DESIGN EXCELLENCE JURY PANEL MEETING | 6 JUNE 2022 | DEVELOPMENT APPLICATION JURY REVIEW

FEBURARY – MARCH 2023 | DEVELOPMENT APPLICATION DESIGN EXCELLENCE JURY REVIEW

The purpose of this paper is to set out the Design Jury Review process for the development at 197 Church Street Parramatta, that has led to modest amendments to the plans.

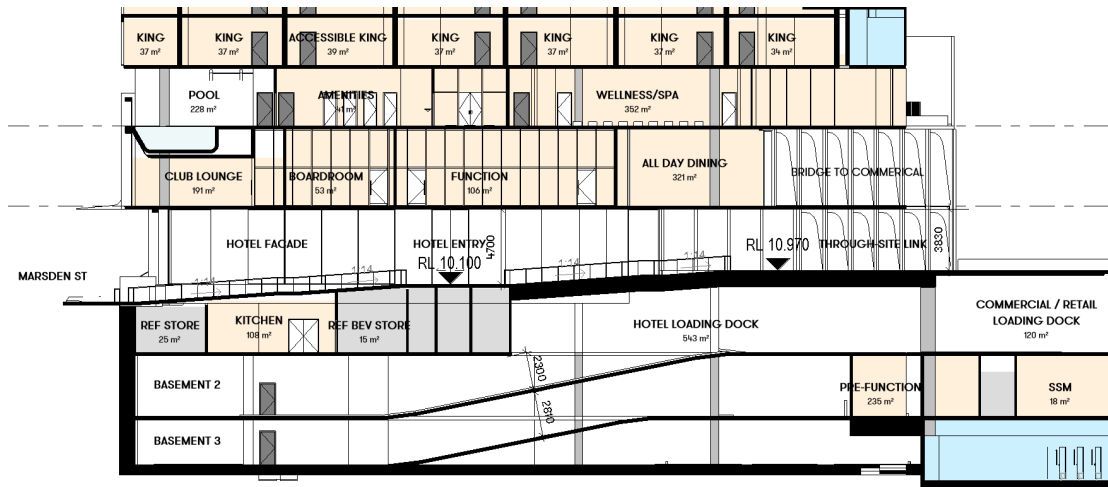
On 17 February 2023 the Design Jury responded in relation to the above sketch noted the improvements set out in the sketch and sought that more space still be given to the public domain. The Jury noted that the confluence of cars, drop off and pedestrian movements remained too compressed and that some consideration could be given to impacting on the ground level of hotel by reducing GFA.

On 28 February 2023 the Jury noted that they supported the proposal and that amended plans should be prepared for submission to the Council. The Jury noted that in the preparation of amended plans that –

- The Hotel colonnade planter was not necessary;
- A section would assist; and
- Turning diagrams and a review of the ramp grades should be undertaken.

On 27 February 2023 a revised sketch was sent to the Design Jury that –

- Allocated more space to the ground plane movement of pedestrians and vehicles;
- Reduced the GFA in the Hotel lobby; and
- Had been considered against traffic and structural requirements.
